S.I. No. 268 of 2025

VEHICLE REGISTRATION AND TAXATION (AMENDMENT)
REGULATIONS 2025

These Regulations amend the Vehicle Registration and Taxation Regulations, 1992 (S.I. No. 318 of 1992) to introduce a green stripe on registration plates for vehicles that emit no CO₂ tailpipe emissions.

Diagram No. 3”,

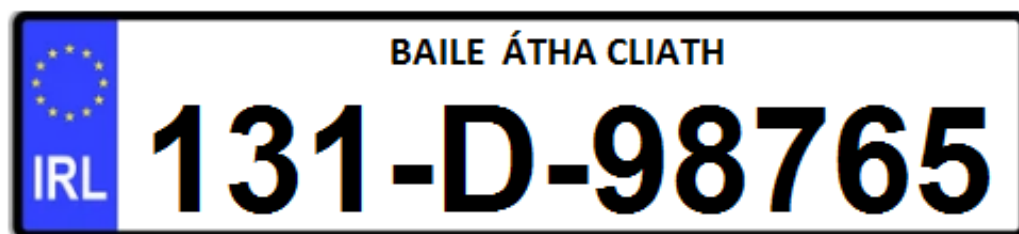
- (a) in paragraph 2A by the substitution of the following for “Diagram No. 3”:
